SITE DEVELOPMENT PLANS FOR BANK OF AMERICA

SECTION 15, TOWNSHIP 27, RANGE 24 BLOOMINGTON, HENNEPIN COUNTY, MN

SHEET NUMBER
L100

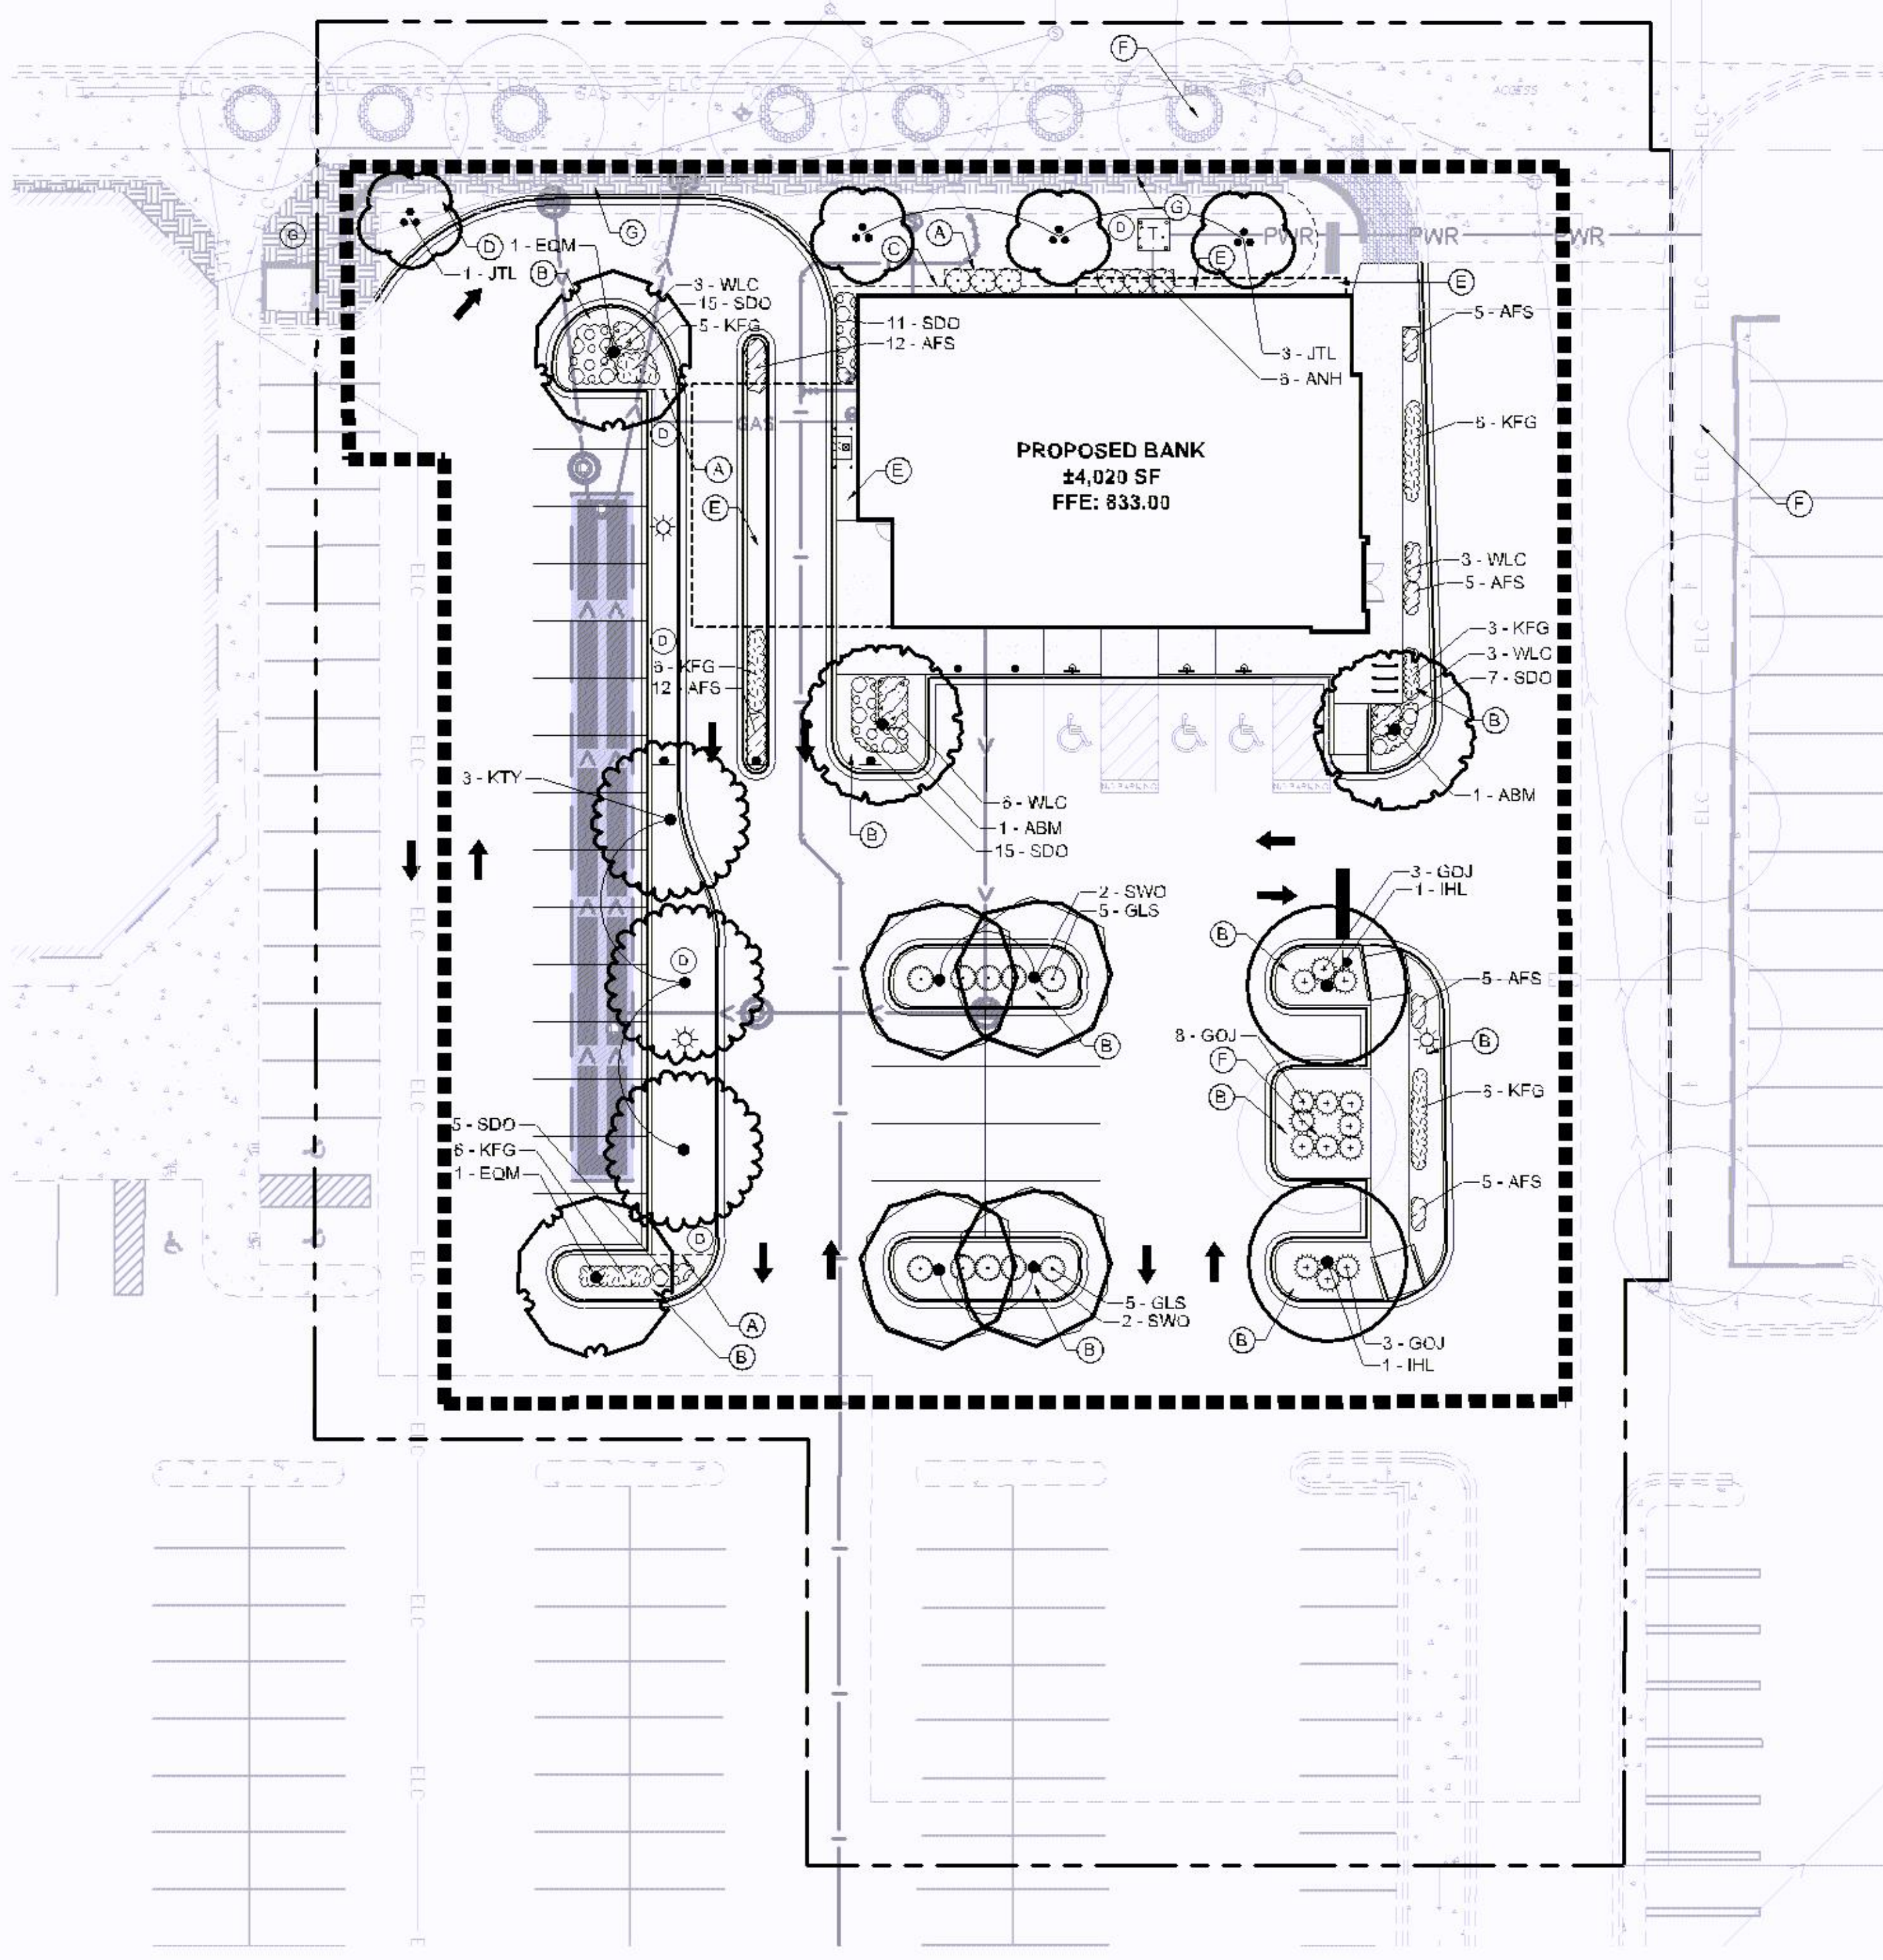
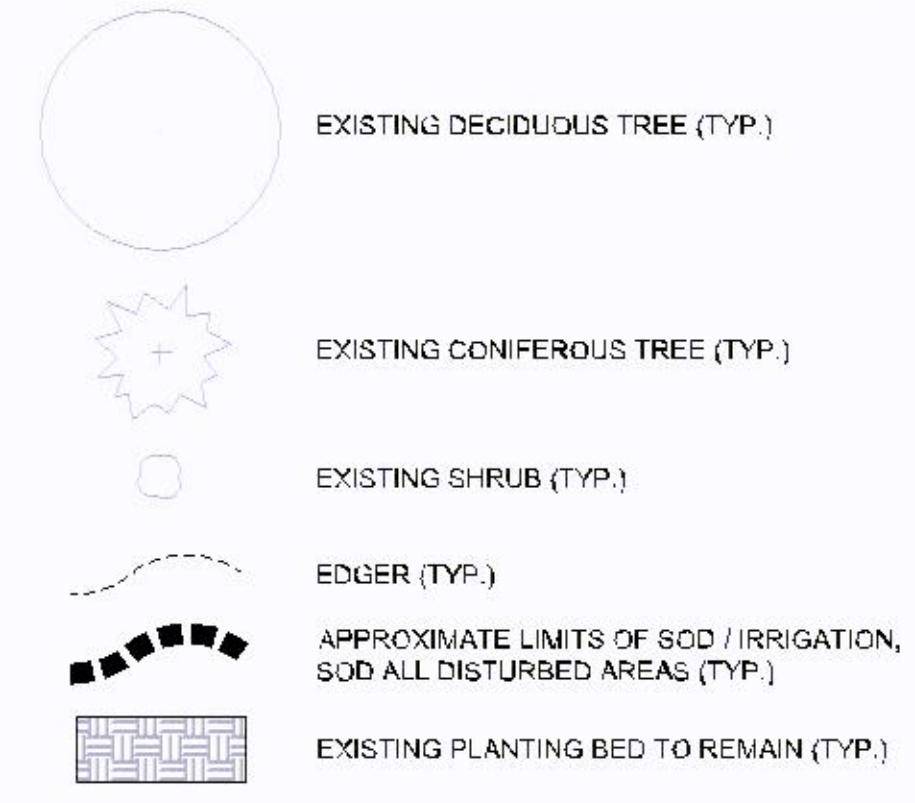
Document species of existing trees to verify they are not on the City's prohibited list (Sec. 18.03).

B North Elevations

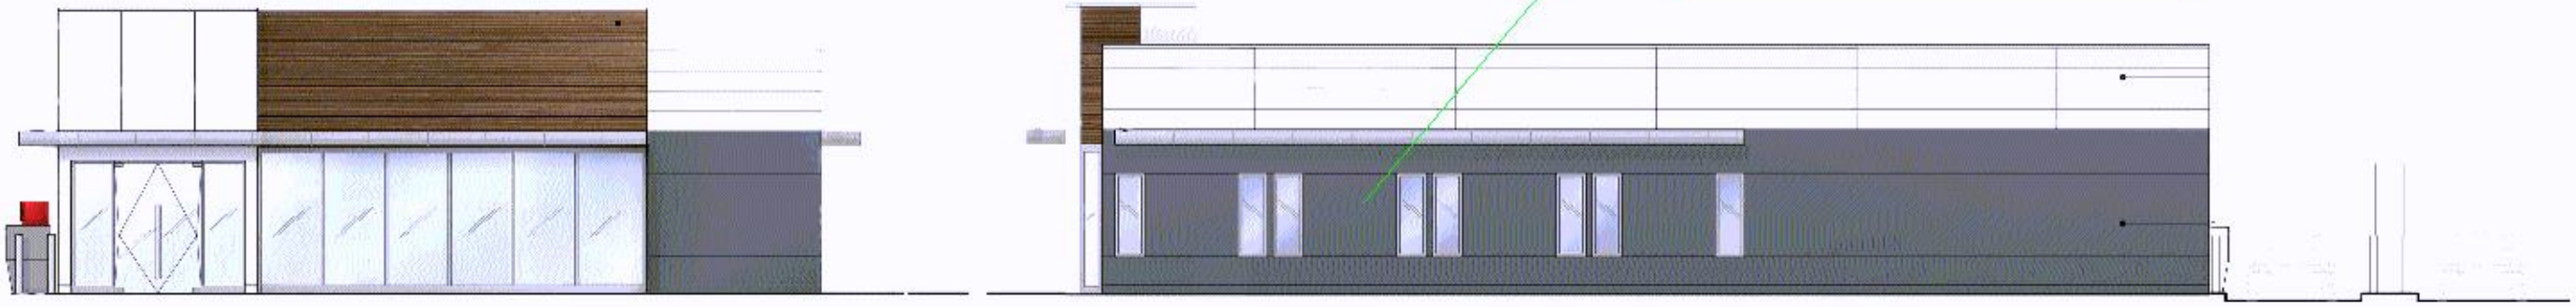
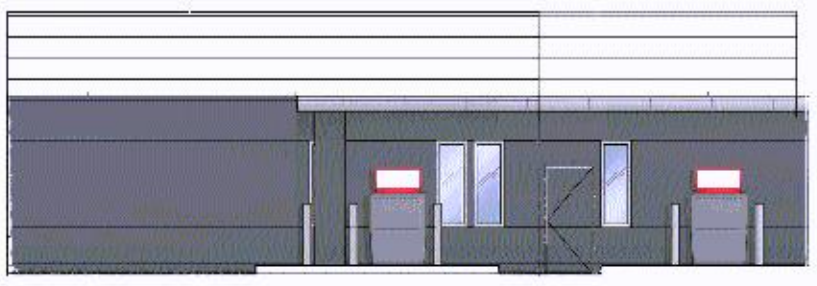
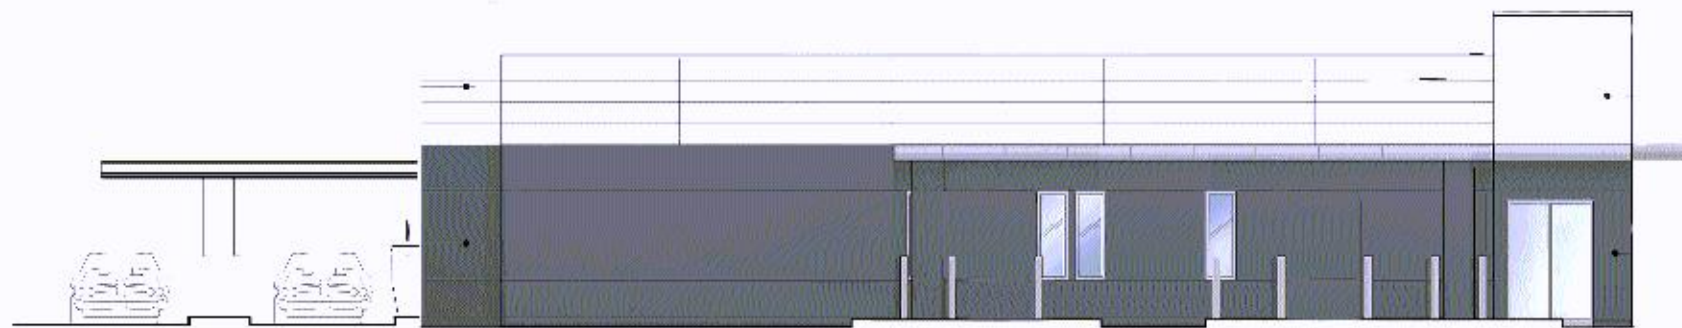
Section 21.301.03(a)(3) of the City Code requires architectural unity in terms of style, color and exterior materials among non-residential buildings constructed on one site. The other structures in the planned development are constructed of brick and are brown and dark red in color. The proposed building is not related in style, color or exterior material and requires modification.

50% of the northern elevation between two and ten feet in height must consist of transparent windows (Sec. 21.301.03(b)(1)). West 98th Street is the primary facade. More transparent windows are needed on this north building elevation.

Metal panels must comply with the City's Exterior Materials and Finish Policies and Procedures Guide. Panels will be reviewed for thickness, durability and finish warranty (30-year minimum required).
